**Hi-Fi Products
Service Bulletin**

Model: STR-GX67ES

No. 240R1

Subject: Hissing Noise In Rear Surround Channel

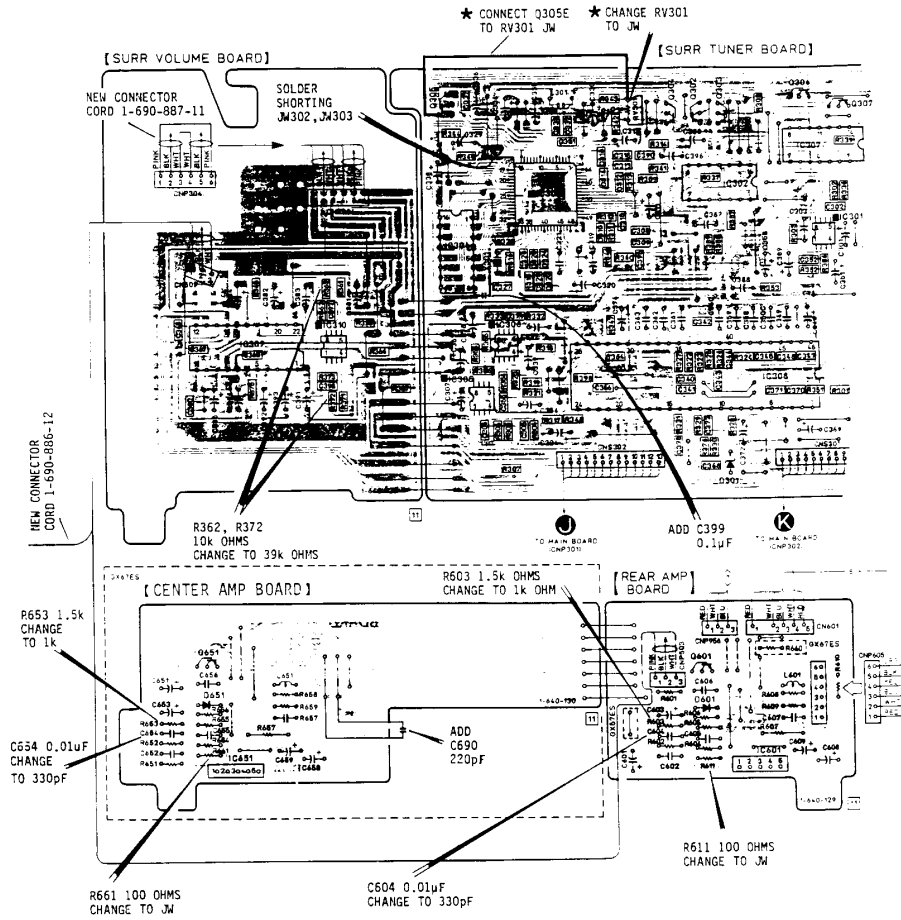
The rear surround channel has a high frequency hiss present which is most noticeable with the master volume turned up at least 50%, the rear channel level at 0db and no signal source present.

1. Remove the connector cord which connects CN509 and CNP503.
2. Remove the connector cord which connects CNP304, CNP505 and CNP502.
3. Change the values of resistors R362 and R372 on the SURR VOLUME BOARD from 10K to 39K.

4. Add a 0.1uf capacitor as C399 on the SURR TUNER BOARD.
5. Form a solder bridge between jumpers JW302 and JW303 on the SURR TUNER BOARD.
6. Change the value of R603 on the REAR AMP BOARD from 1.5K to 1K.

7. Short R611 on the REAR AMP BOARD with the supplied jumper wire.
8. Change the value of C604 on the REAR AMP BOARD from 0.01uf to 330pf.
9. Change the value of C654 on the CENTER AMP BOARD from 0.01uf to 330pf.

10. Change the value of R653 on the CENTER AMP BOARD from 1.5K to 1K.
11. Short R661 on the CENTER AMP BOARD with the supplied jumper wire.
12. Add a 220pf capacitor as C690 on the CENTER AMP BOARD.

13. Short terminal 3 on RV404 which is connected to CNP505 to terminal 4 of RV404 which is connected to CNP505 on the MOTOR VOLUME BOARD. Use the supplied jumper wire.

14. Install the supplied 4-leaded connector cord.
15. Install the supplied 1-lead connector cord.

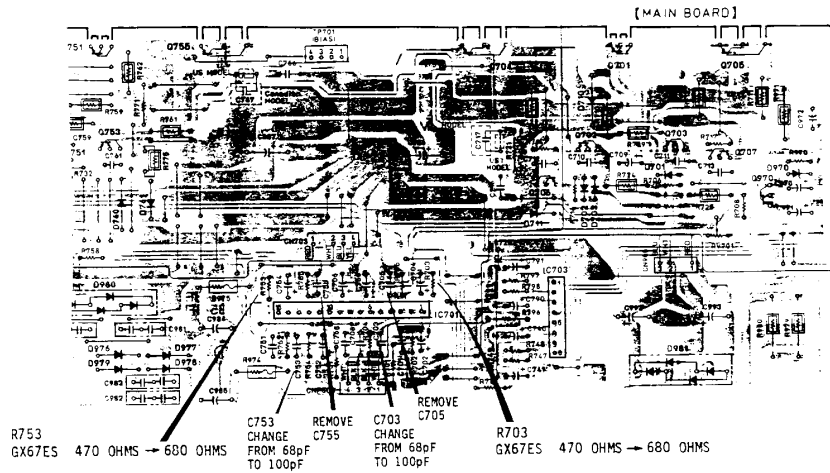
★ NOTE:
DUE TO THIS MODIFICATION, THE INPUT SENSITIVITY AND OUTPUT LEVELS
ARE CHANGED AS FOLLOWS:-

INPUT SENSITIVITY

CD, VIDEO 1, 2
TAPE, DAT 150mV → 250mV
TAPE MONITOR

OUTPUT LEVELS

VIDEO 1 AUDIO OUT
REC OUT 150mV → 250mV
